Docket: NRC-2011-0148

Supplemental Environmental Impact Statement for the Ross In-Situ Uranium Recovery Project in Crook County, Wyoming

RE: NRDC Comments on *Draft Supplemental Environmental Impact Statement for the Ross ISR Project in Crook County, Wyoming*, Docket ID NRC-2011-0148.

26. Figure 1. Variation plot for uranium and radium-226 showing distinct radium-226 values for 19xx18, which are due to the capture of the Nubeth contamination plume.

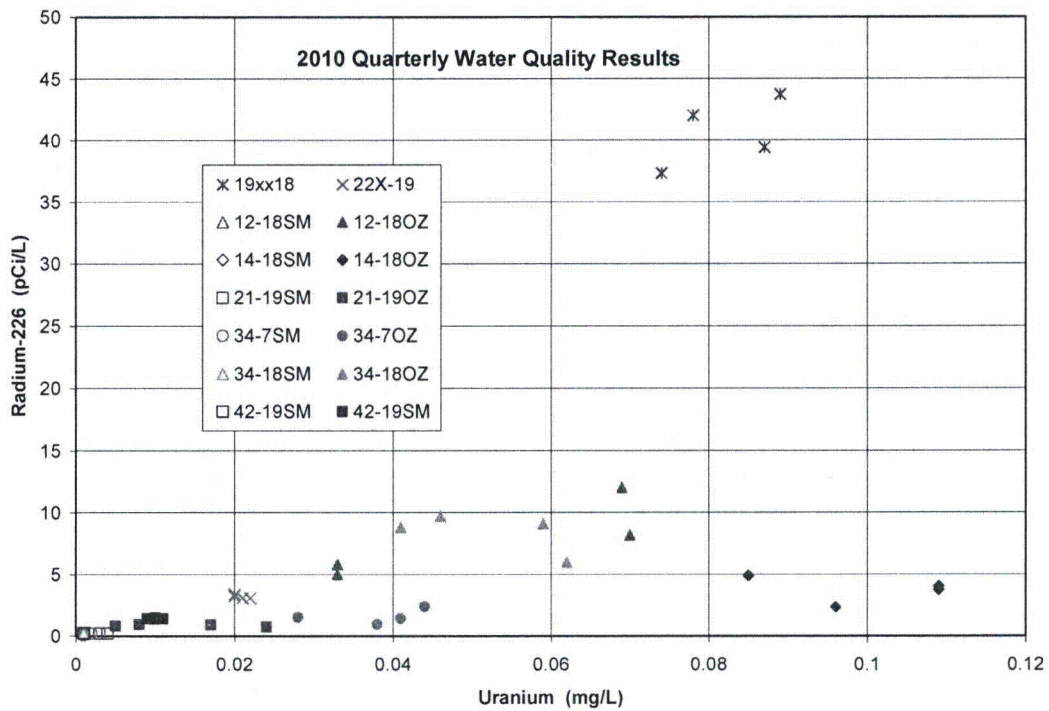
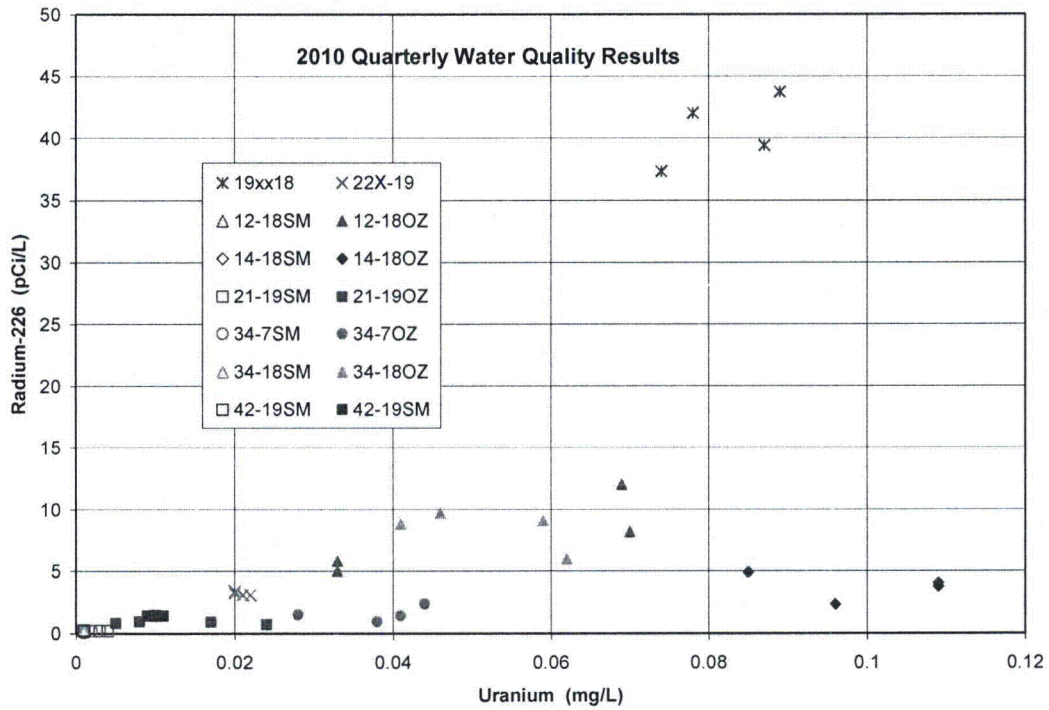
Examining the established scientific facts it is apparent, in my expert judgment, that the probability is vanishingly small that ISL-contaminated groundwater can be restored to baseline values when those values are properly determined with valid scientific and statistical techniques (*i.e.*, lower concentrations than heretofore presented by Strata or NRC).

25. Failure to restore the groundwater under the Nubeth pilot-scale ISL operation is clearly evident in the consistently elevated uranium and radium-226 concentrations observed in samples from industrial well 19xx18 (Figure 1), which served as the extraction well to the Nubeth pilot-scale test (Figure 3.15 in the SEIS). The uranium-radium-226 trend observed for all Strata cluster wells from the OZ horizons and industrial well 22x19 lies well below the radium-226 values for 19xx18, and the high radium-226 values can only be explained by the capture of the contaminated plume that remains from Nubeth's failure to restore groundwater after their six-month pilot-scale test. In my expert opinion, failure to restore the groundwater after a short six-month pilot-scale project should have clearly communicated to the NRC staff that it will not be possible to restore a full-scale ISL operation in 8 months (DSEIS at 2-33).

35. Figure 2. Water-quality results for sodium and sulfate indicate groundwater mixing of the ore zone (OZ) and overlying horizon (SM).

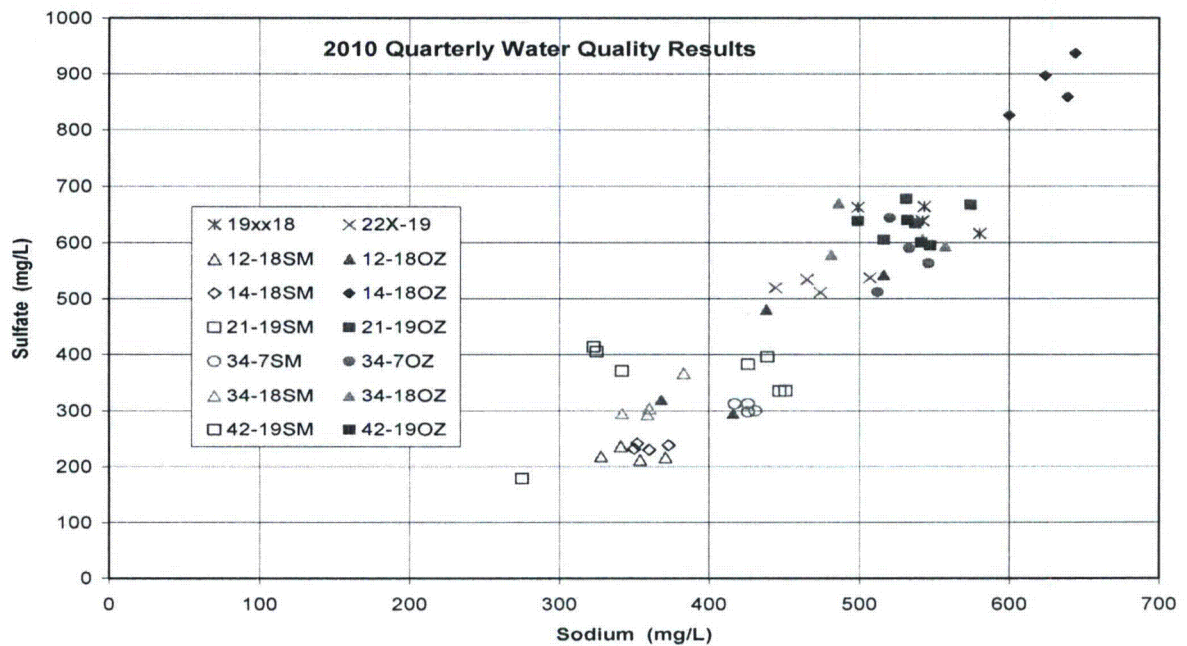
34. Demonstration of adequate hydrologic control is not a trivial matter because groundwater communication between the SM and OZ horizons is evident in the 24-hour pump test data from well 12-18OZ and the water-quality results for sodium and sulfate (Figure 2). Groundwater from the ore horizon (OZ; solid symbols) generally has higher sodium and sulfate, relative to the overlying groundwater (SM). However, mixing of the groundwater from these two horizons is clearly indicated by the linear trace of the sodium and sulfate trend on Figure 2. In my expert opinion this is unquestionably demonstrated by the mid-location of plotted samples from 22X-19, a well that is screened through the OZ and SM zones (Section 2.7.3.3.1, p.2-169, Strata TR). If 14-18OZ is taken as the unmixed groundwater from the ore horizon, all other OZ samples are shown to have a component of SM water, as they lie between 14-18OZ and 22x-19. Note that the strong mixing between the horizons is unequivocal for samples from 12-18OZ, which plot with the samples from 22x-19 and the SM horizon.

36. Figure 2 also illustrates that, the closer that a pair of samples plots for a given cluster well (e.g., 12-18SM and 12-18OZ), the higher the probability for groundwater contamination by communication between the two groundwater zones during ISL operations. In contrast to mixing between the 12-18 horizons, 14-18SM and 14-18OZ samples cluster tightly and are well separated on the plot. An explanation for the distinct separation of the 14-18 horizons on the sodium-sulfate plot may be that the density of exploration boreholes is lower around this cluster well and less communication between the SM and OZ horizons has occurred (*i.e.*, 14-18 may provide a snapshot of the distinct chemistry of the horizons prior to the drilling of thousands of exploration boreholes).

**Figure 2.6 [from page 2-4 of SEIS]
Schedule for Potential Lance District Development**

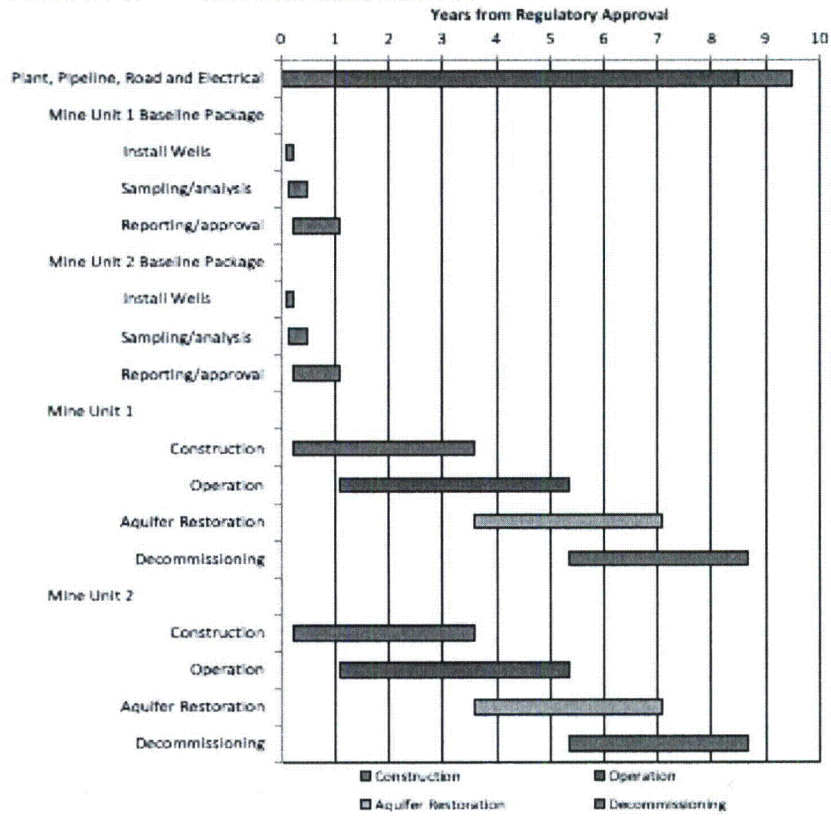
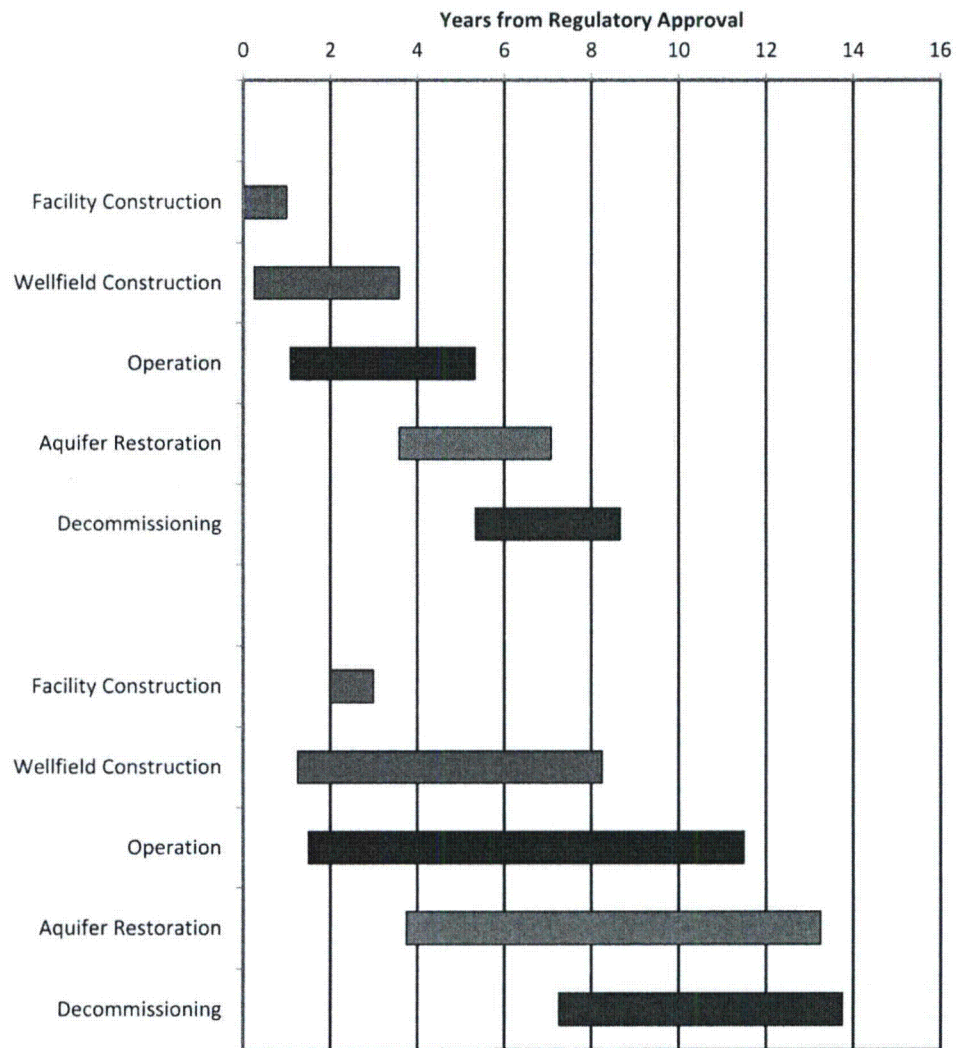
(a) The referenced Figure 2.6 contains no reference to a proposed “Ross Project,” but rather its title states that it describes a “Schedule for Potential Lance District Development.”

(2) Is the current title for Figure 2.6 in error, or is it the figure itself that is erroneous?

(b) Figure 2.6 shows an “aquifer-restoration only phase” being attained about 11.75 years after regulatory approval.

13. Below are two Figures, from the ER and DSEIS, respectively, that suggest a significant evolution has occurred in the Applicant's and the NRC's strategy and timing for uranium recovery operations in the Lance District beyond the Ross Project. The first figure below is cited in ER Section 1.3.2 on the "*Ross ISR Project Schedule*," and shows a 9.5 year project. This exact figure is not repeated in the SEIS, but one resembling it appears on SEIS page 2-8, but now carries the title, "Figure 2.6: Schedule for *Potential Lance District Development*," and conveys a timeline of 14 years, 4.5 years longer than the schedule described in the ER (see next page for figure).

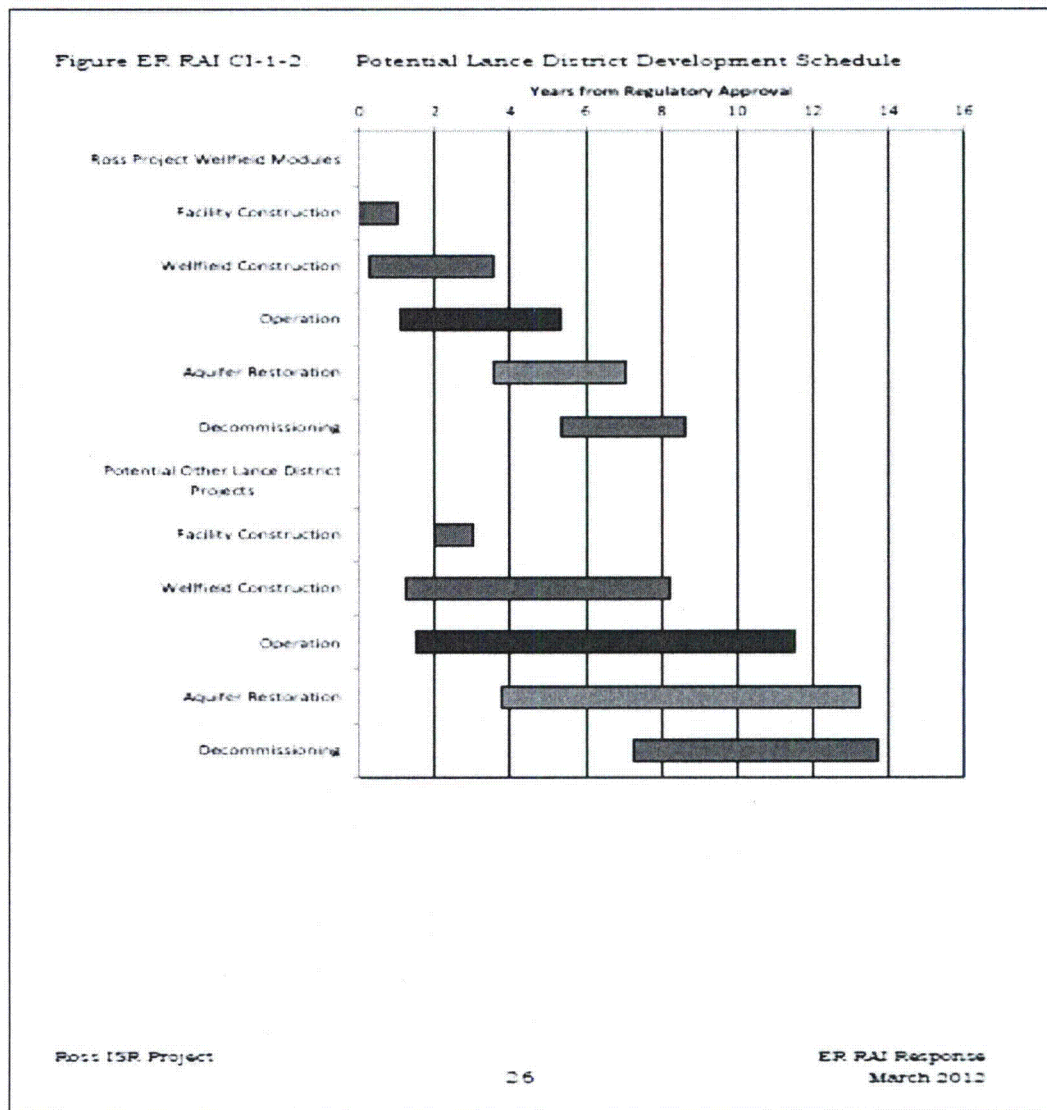
14. If one traces the above figure back to its source (“Strata, 2012a” RAI Response), one finds that the NRC Staff has deleted the subheadings “Ross Project Wellfield Modules” and “Potential Other Lance District Projects” that were present on the above chart in the RAI, subheadings that indicate that the Proposed Action *is really to license a single large ISR project via the Ross Project license and subsequent license conditions or amendments*

thereto, in which the various subsequent development “phases” clearly significantly overlap each other in time, and “satellite facility” construction *begins just a year after the first Ross Project well-field goes into operation*, and satellite well-field construction *begins less than a year after construction of the Ross Project well-fields*. Here is the March 2012 RAI Figure:

16. Note the NRC Staff's deletions (from the previous chart) of the headings "Ross Project Wellfield Modules" and "Potential Other Lance District Projects" from the above chart provided by Strata. Otherwise it is the same chart.

Figure ER RAI CI-1-1. Potential Future Lance District Projects

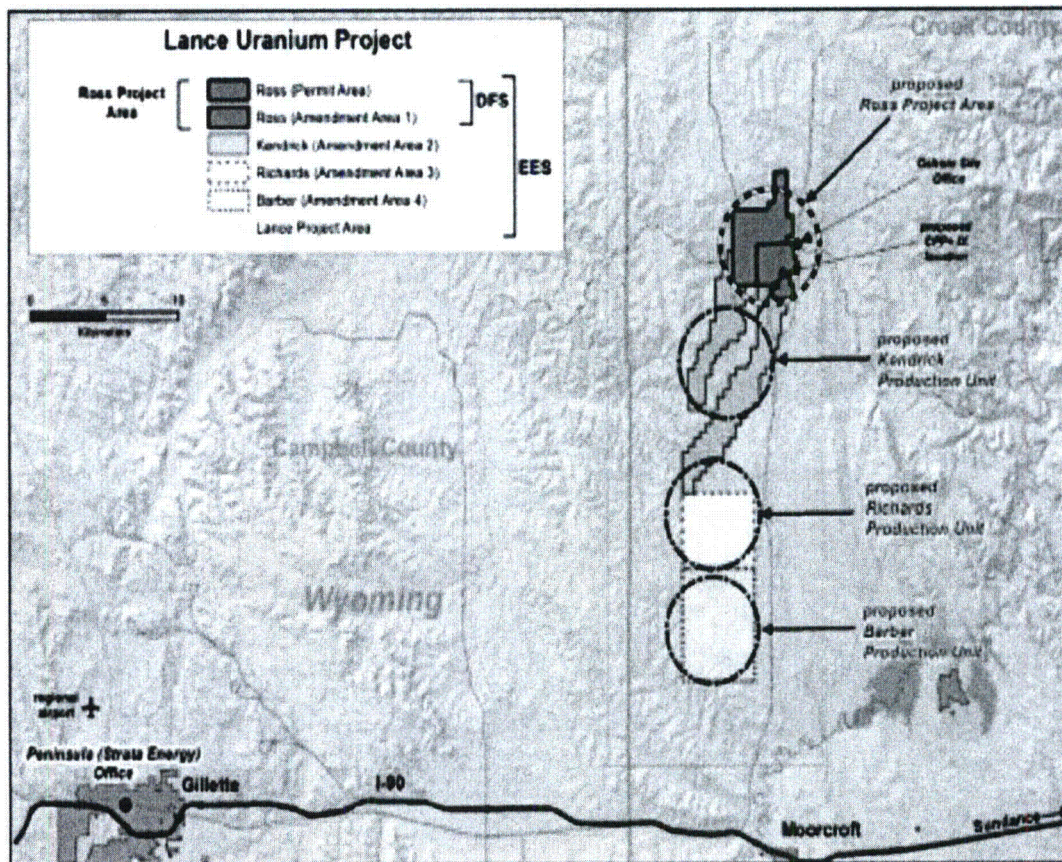
17. Below is Strata's plan, provided to NRC in the RAI of March 2012, and now reproduced on page 2-4 of the DSEIS, to march through the entire Lance District uranium roll-front deposit over the 14 years following regulatory approval. It reveals that the proposed "Ross Permit Area" subjected to analysis in the ER and DSEIS is but a small fraction of the total area to be mined. It was the NRC Staff's NEPA obligation, not Petitioners', upon receipt of this information to modify the scope of the Proposed Action in the DSEIS to fairly reflect the reality that this expanded sequence of planned "production units" would have much wider environmental impacts, over a more defined timeframe, than previously described in the ER.

20. Figure 1: Resource Area Location Map (Source: Peninsula Energy, January 23, 2013)

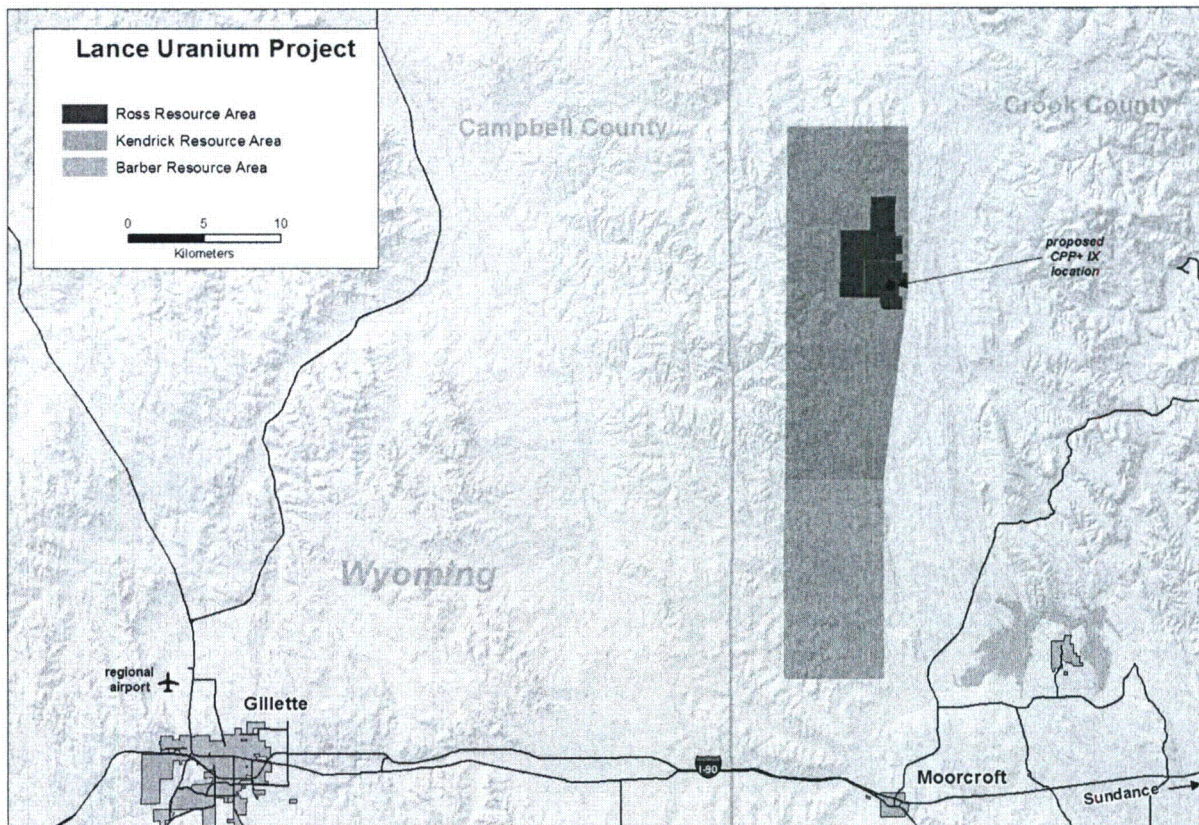
- 18.
19. Below is another map (dated 01/23/13) from the Australian corporate parent, Peninsule Energy, which differs from the previous maps in the ER, showing an expanded "Ross Resource Area" within an even larger "Kendrick Resource Area, which is in turn contiguous at its southern boundary with a "Barber Resource Area." This map is *prima facie* evidence that even the basic boundaries within which the environmental impacts of this proposed licensing action will be felt have not yet been defined, much less all the potential environmental impacts adequately considered as required under NEPA.
